### Questions from the October 26, 2022, Email

#### **Additional Questions from the November 3, 2022, Teleconference**

**Figure 9-4 Turbine Building Geoprobe Soil Scanning Locations**

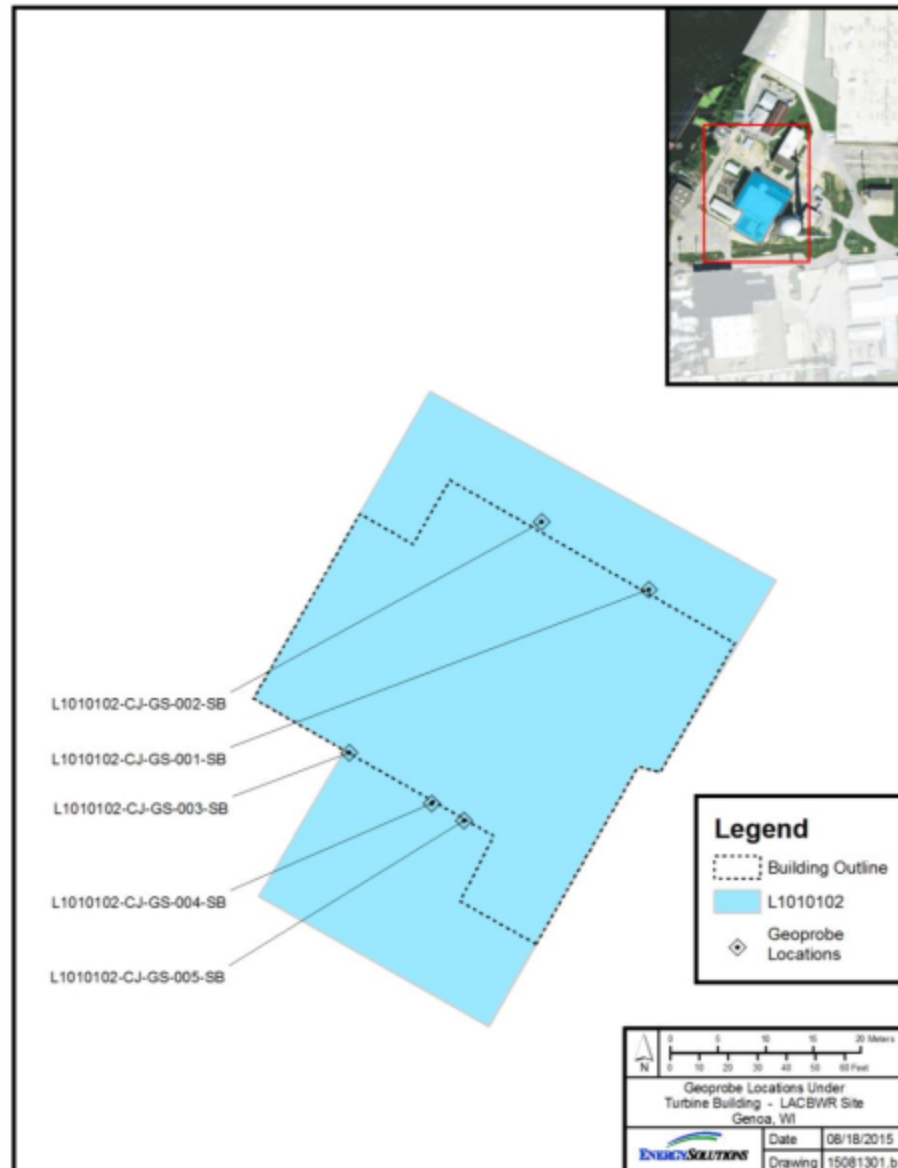
3. Explanation on soil disturbance in sump area of TDS-B.

*Contamination found outside the of the sump area was a result of excavation of soil spreading contamination in the immediate vicinity of the RPGPA sump.*

*Subsurface characterization of the areas around and beneath the Turbine Building show that there was no significant surface or subsurface soil contamination. Table 9-4 of the Characterization Survey Report for 2014 (GG-EO-313196-RS-RP-001, Revision 0), below, shows the results of the subsurface soil analysis performed in survey unit L1-010-102, which were to a maximum depth of 4 meters.*

The figure below (Figure 9-4 of LC-RS-PN-164017-001) shows the locations of the soil samples depicted in the above table.

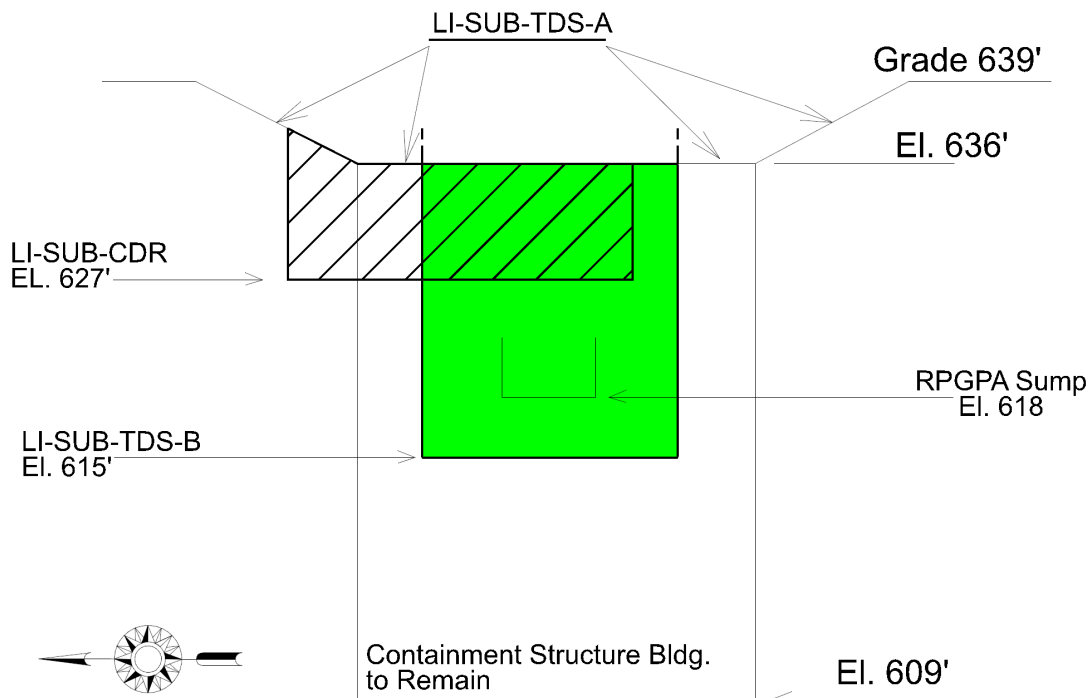
5. CDR, TDS-A, and TDS-B survey and backfill timeline.

*Excavation and demolition of the Pipe Tunnel/RPGPA (L1-SUB-CDR) was completed in August to September 2017. L1-SUB-CDR was excavated to approximate elevation 627' and L1-SUB-TDS-B was excavated to approximate elevation 618'. Backfill of the area was*

completed between 09/20/2017 and 09/26/2017, except for the RPGPA/Sump area (L1-SUB-TDS-B) which was backfilled 04/18/2019. L1-SUB-CDR was backfilled to approximate elevation 629', and L1-SUB-TDS-B was backfilled to approximate elevation 636'.

## North-Facing Layout of CDR, TDS-A, and TDS-B Excavations

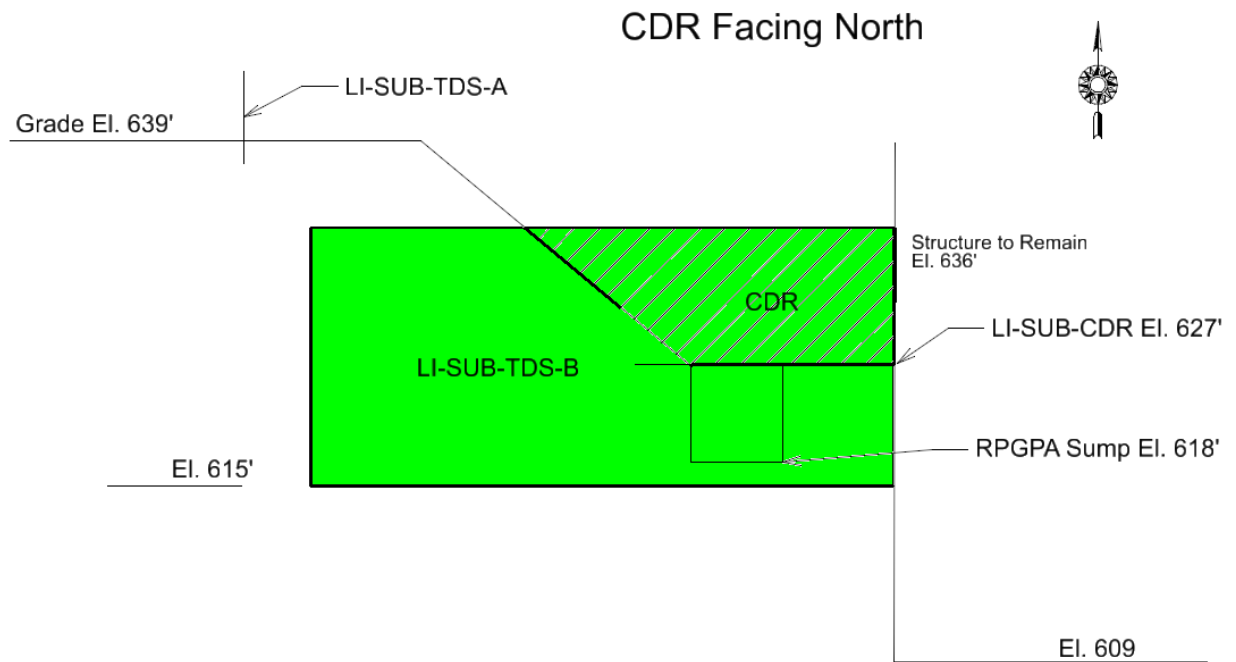
6. We are still trying to piece together the various elevations and survey unit overlap. At what elevation was the CDR soil at the time of the CDR FSS? It is our understanding that the bottom of the trench box was at the 618’ elevation, but the team does not know the elevation of the soil outside of the trench box that was still within the footprint of the RPGPA survey unit. Some of this area is the sloped walls to the trench box, but what was the elevation of the top of the sloped walls? How does that elevation compare to the rest of the CDR survey unit? Also, is the RPGPA survey unit boundary at the top of the sloped wall?

7. The RCI response states, “Portions of the backfill covering the final CDR excavation surface were excavated to slope the TDS-A excavation, but the final CDR excavation surface that was subject to FSS was undisturbed.” Please clarify if this is stating that parts of the CDR survey unit that did not overlap with TDS-A, were excavated to provide a slope into the TDS-A excavation. Or is this stating that portions of the part of backfilled CDR that did overlap with TDS-A were excavated during the FSS of TDS-A? Please confirm the elevation of TDS-A when it received FSS as compared to the elevation of CDR where it overlapped with TDS-A.

Portions of L1-SUB-TDS-A consisted of sloping to enable FSS Technicians to access L1-SUB-TDS-B. L1-SUB-TDS-A never reached the extent of where L1-SUB-CDR was excavated to. In the vicinity of L1-SUB-CDR and L1-SUB-TDS-B, the elevation of L1-SUB-TDS-A ranged from approximate elevations 639' to 632'. The FSS of L1-SUB-TDS-A was performed 06/26/2019 through 07/12/2019. L1-SUB-TDS-A is at different elevations than L1-SUB-TDS-B, the majority of which is higher than L1-SUB-TDS-B.

As explained above, no excavation affected the final surface (subject to FSS) of another excavation. These survey units overlap in some areas on the (x,y) axis, but when taking into account the depth (z) of each excavation, the surfaces subjected to FSS do not interact. All isolation and control measures were adhered to, the main mechanism being the use of backfill, to ensure survey results were not compromised.

Below are figures in support of this response.
